Staff Report

Item: 2045 Molalla Rd NE, "Woodburn Place West Apartments" (CU 22-01)

Conditional Use CU 22-01 (Type III) with proposed site development DR 22-08 Woodburn Place West Apartments: Commission decision.

Exhibit CU2b (blue indicates extension of walkway poured concrete)

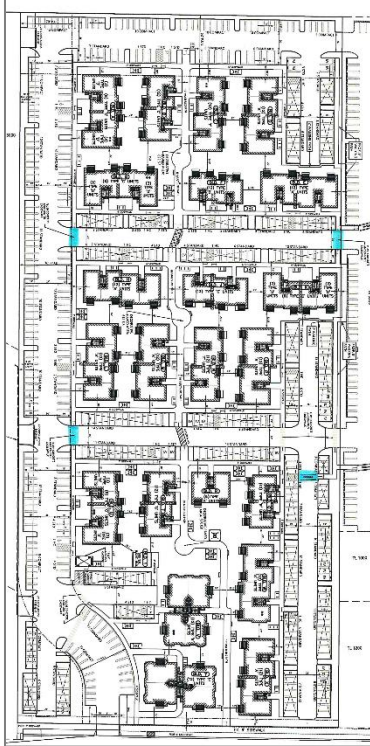
- b. Walkways: Per WDO 3.04.06d.2, applied such that per Exhibit CU2b below min 4 crossings shall be extension of walkway poured concrete:

Exhibit CU15a(3)

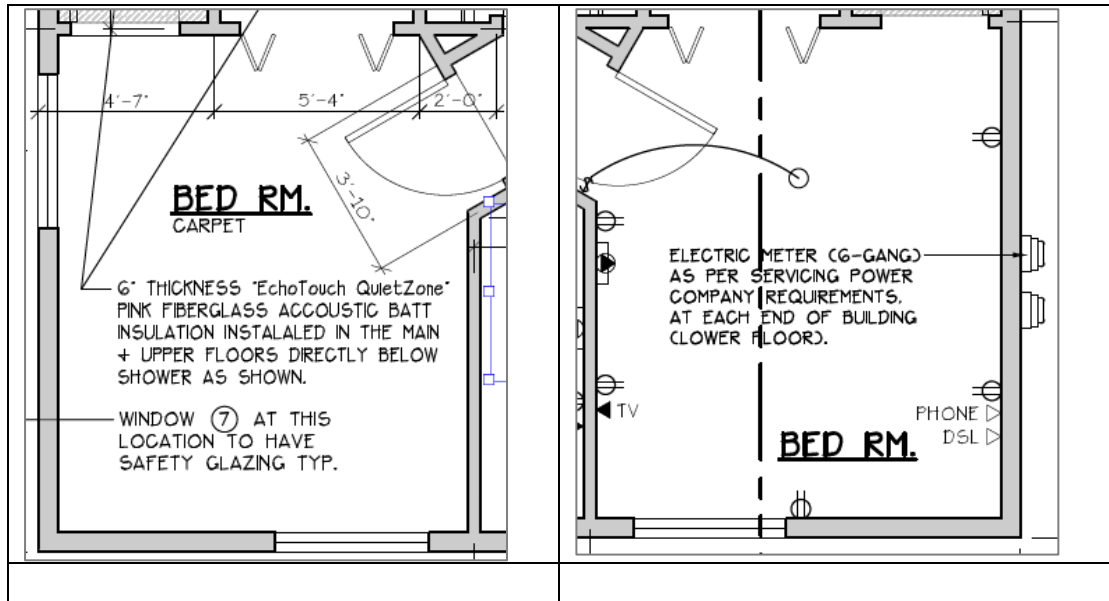
- (3) Per room: Within apts, every habitable room abutting a building exterior wall shall have min 1 window. Each ground floor corner room proposed through land use review to one on each elevation shall continue to have 2; however, where the developer to propose additional location(s) of exterior wall-mounted utilities and meters, then for each room, the second window may shrink to min 6 sq ft and be horizontally proportioned.

Exhibit CU15a(4)

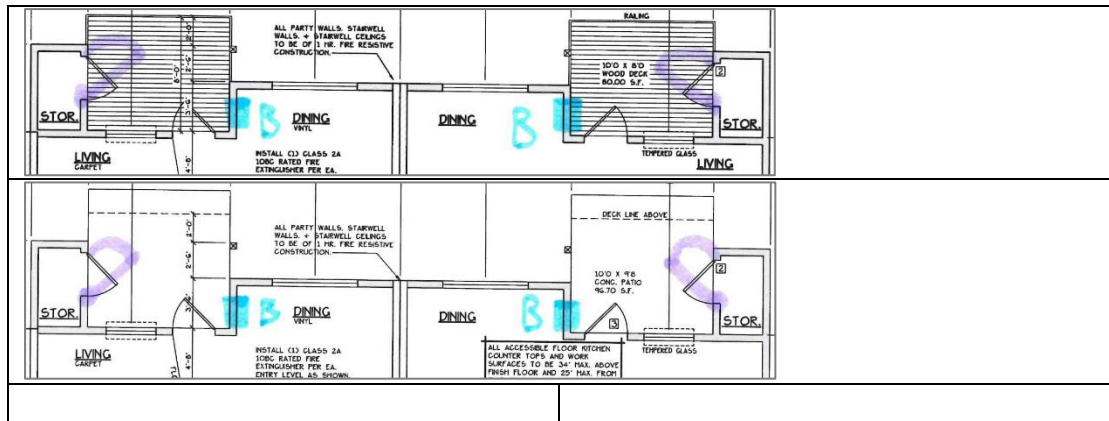
- (4) For units with floor plans resembling Exhibit CU15a(4) below with 3 ft or more offset, each rear in the wall dividing dining/living area and patio or balcony shall have a window min width 1.5 ft and min area 7.5 sq ft approximately where the blue letter “B” indicates:

Exhibit CU21

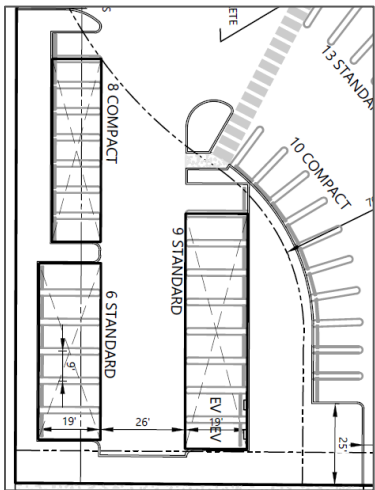
CU21. Carports in sewer forced main easement: Regarding the existing sewer forced main that runs north-south near the west lot line, the existing easement for it that runs along the west property line (County Reel 143, Page 1685, dated 1978), and the carports proposed within the south end of the easement, at the subject property SW corner, the developer shall do one of the following:

- a. Remove or relocate the proposed carports while maintaining conformance with WDO 3.05.03F.2, due by building permit application;
- b. Through PW, rework a sewer forced main south segment to be east, sufficiently within and following a new proposed off-street PUE serving as Street Corridor "J", due the same as Condition G4; or
- c. Through PW, either obtain a revocable permit or enter into a written agreement, either legal instrument allowing for the carports to remain on terms set by PW, due by either when PW establishes or building permit issuance (of the structural permit for whatever is the first building or structure in the development), whichever is earlier.

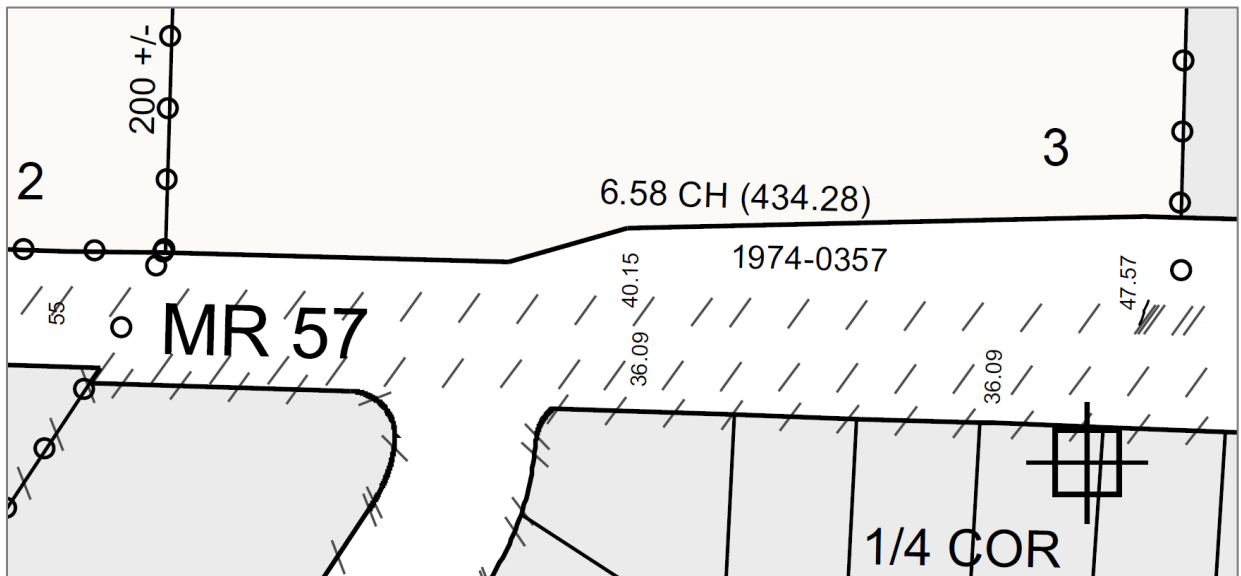
Because the planned ROW is 100 ft (50 ft “half-street”, each side of centerline), and the existing ROW varies from about 83.7 ft at the east to about 63.6 ft at the west (47.6 ft from centerline at the east and about 27.5 ft at the east), variable width dedication is required. (Rather than rely on the tax map, the developer will research or commission a survey as needed to determine exact widths and what area to dedicate as ROW.)

D1. ROW: To meet WDO Figure 3.01B, as part of recordations and regarding OR 211, the applicant shall dedicate (a) variable width ROW resulting in half-street ROW that is uniform 50 ft wide min measured from road centerline, and (b) a streetside PUE min 10 ft.

Exhibit CU2b (blue indicates extension of walkway poured concrete)

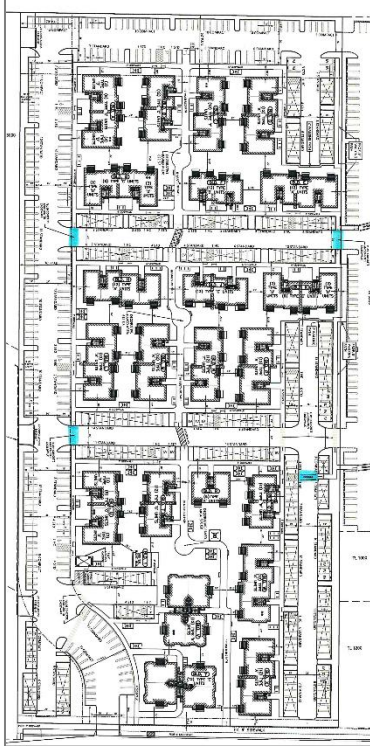
- b. Walkways: Per WDO 3.04.06d.2, applied such that per Exhibit CU2b below min 4 crossings shall be extension of walkway poured concrete:

Exhibit CU15a(3)

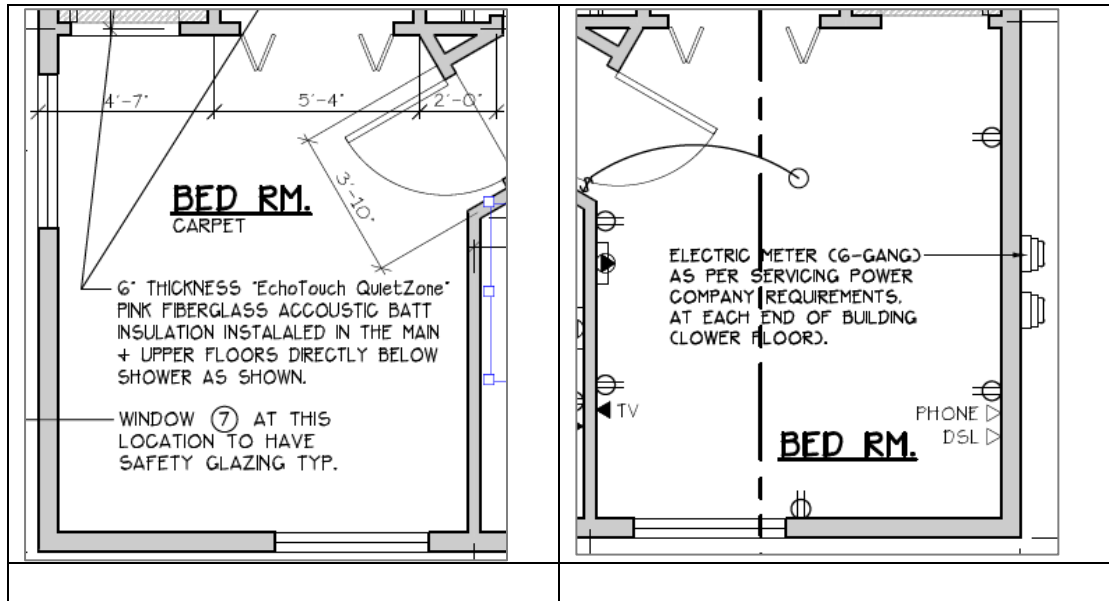
- (3) Per room: Within apts, every habitable room abutting a building exterior wall shall have min 1 window. Each ground floor corner room proposed through land use review to one on each elevation shall continue to have 2; however, where the developer to propose additional location(s) of exterior wall-mounted utilities and meters, then for each room, the second window may shrink to min 6 sq ft and be horizontally proportioned.

Exhibit CU15a(4)

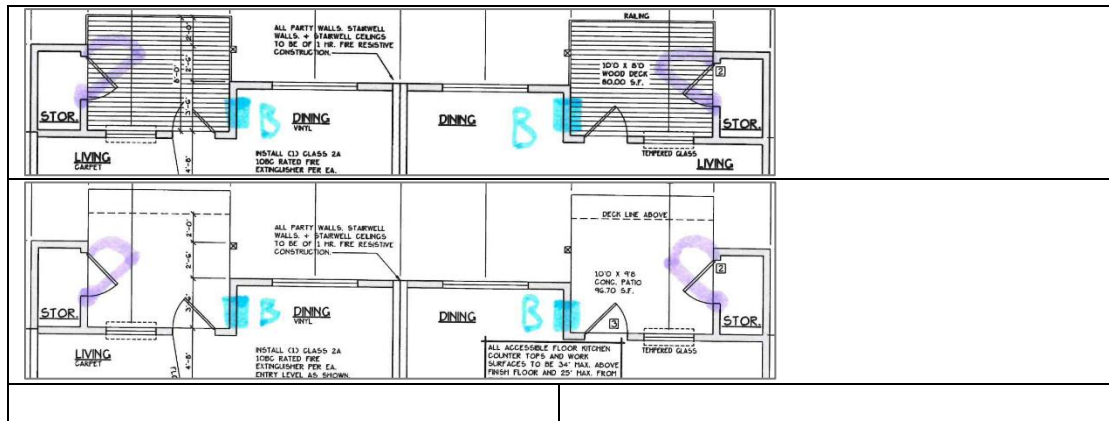
- (4) For units with floor plans resembling Exhibit CU15a(4) below with 3 ft or more offset, each rear in the wall dividing dining/living area and patio or balcony shall have a window min width 1.5 ft and min area 7.5 sq ft approximately where the blue letter “B” indicates:

Exhibit CU21

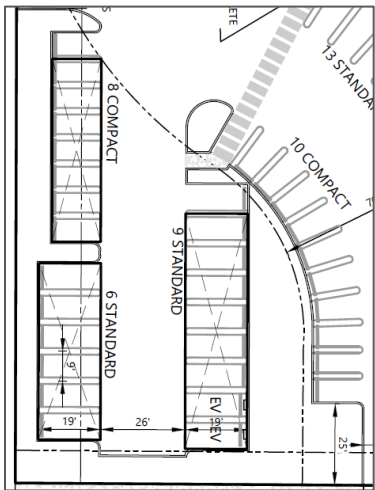
CU21. Carports in sewer forced main easement: Regarding the existing sewer forced main that runs north-south near the west lot line, the existing easement for it that runs along the west property line (County Reel 143, Page 1685, dated 1978), and the carports proposed within the south end of the easement, at the subject property SW corner, the developer shall do one of the following:

- a. Remove or relocate the proposed carports while maintaining conformance with WDO 3.05.03F.2, due by building permit application;
- b. Through PW, rework a sewer forced main south segment to be east, sufficiently within and following a new proposed off-street PUE serving as Street Corridor "J", due the same as Condition G4; or
- c. Through PW, either obtain a revocable permit or enter into a written agreement, either legal instrument allowing for the carports to remain on terms set by PW, due by either when PW establishes or building permit issuance (of the structural permit for whatever is the first building or structure in the development), whichever is earlier.
